REVISED AGENDA WASHINGTON COUNTY PLANNING COMMISSION 100 W Washington Street, Room 2000 July 1, 2024, 6:00 PM

WASHINGTON COUNTY PLANNING COMMISSION REGULAR MEETING AND WORKSHOP May 6, 2024

A preliminary consultation was held on June 5, 2024 at 10:00 a.m. via a Teams meeting. A concept plan was presented for the proposed new construction of a convenience store with fuel stations and a fuel canopy for both auto and commercial fuel. The property is located at the corner of Crayton Boulevard and Showalter Road and is currently zoned HI (Highway Interchange).

SITE PLAN STAFF REPORT

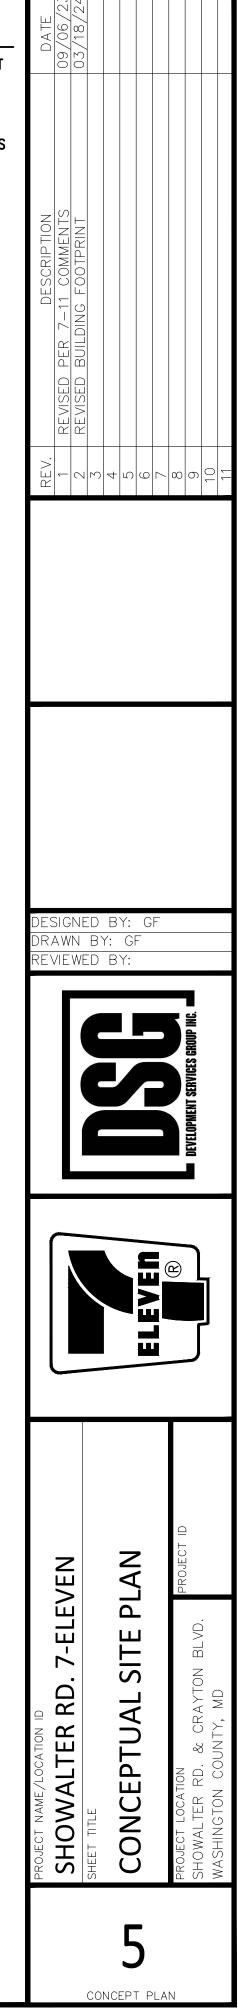
Ms. Wagner-Grillo stated that this project meets the definition of the County's mixed use retail classification. She noted that a convenience store definition was recently adopted and is expected to be in effect within the next month. The proposed plan meets the newly adopted definition of a convenience store, which permits 5 high-flow fuel pumps, 7 truck parking spaces per 1,000 sq. ft. of gross leasable space, and a maximum of 8 fueling stations per island (2 islands permitted) for a total of 32 individual pumps. The definition also allows for electric vehicle parking/charging stations, car washes (no truck washes), and restaurants that provide indoor and outdoor seating. Ms. Wagner-Grillo explained that the commercial site plan checklist for Planning & Zoning is required for the submittal and, if followed, will cut down on the revisions required throughout the site plan process. Screening will be required for the parcels located east of the proposed development to protect these parcels from glare. A photometric plan will be required.

Mr. Franks noted that the current plan shows shared drive aisles along the eastern and southern boundaries with the property line going down the middle of the aisles. Ms. Wagner-Grillo asked if the property is going to be subdivided; Mr. Franks said it would be subdivided. Ms. Calimer explained that a preliminary site plan could be submitted which would combine the subdivision plat, site plan and construction plans in one submission. Following approval of the preliminary site plan, a final plat would be required.

Ms. Calimer stated an ESD Stormwater Concept Plan is required and will be reviewed by the County Engineering Department and the Soil Conservation District. This plan must be approved prior to submission of the preliminary site plan. Ms. Calimer stated that the County has a concurrent review policy; therefore, after the site plan has been accepted by the Department of Planning & Zoning, the developer may apply for permits (at the developer's own risk). The site plan must be fully approved and closed before any permits will be issued. A notification when the site plan is fully approved will be sent to the consultant/developer when all agency approvals and signatures have been obtained.

Mr. Franks asked if this parcel was included in a master plan regional BMP. Ms. Calimer stated the developer will be responsible for storm water management on site. Mr. Franks asked if the County objects to using underground storage for storm water management. Ms. Calimer stated there is no objection; the

developer should follow the regulations and guidelines in the Engineering's site plan checklist. Ms. Calimer noted that this project is located in the Airport Overlay Wildlife Management Area zone. The design of the storm water management area should avoid ponding water to avoid attracting waterfowl.

Mr. Hoeh stated that the property is located within the City's MRGA (Medium Range Growth Area) and is eligible for water service. There is an existing 12-inch water line in Showalter Road that transitions into an 8-inch line running along most of the north side of the property. Mr. Hoeh explained that the anticipated daily use for allocation will be needed, the meter size must be indicated and any fire suppression requirements must be noted on the plan. A pre-annexation agreement will be required. Mr. Franks asked

A representative was not present at the meeting; however, Mr. Neil Doran provided the following written comments: 1) detailed design drawings showing the vertical profile and height above ground of structures such as the fuel canopy and the convenience store must be submitted; 2) locations of habitable buildings, fuel storage tanks and pumps and vehicle parking areas should be labeled; 3) the site plan should depict the runway 02-20 Runway Protection Zone (RPZ) and the dimensions of the easement area; 4) an online 7460 form must be submitted to the Obstruction Evaluation Airspace Analysis of the FAA; and 5) an airspace analysis needs to be completed and submitted to determine impacts.

Mr. Allen stated that this project will need to comply with the County's Forest Conservation Ordinance. Typically, on a commercial project of this size, the project would qualify for using the Payment-in-Lieu option to satisfy forest conservation requirements. Mr. Allen explained that usually on commercial site plans, forest conservation calculations are based on limited disturbance only. However, because the property is going to be subdivided and other factors discussed today, the larger of the calculations of disturbance will be used to determine the mitigation requirement. Forest conservation mitigation will be required when the preliminary site plan is ready for approval, and before the final plat is submitted.
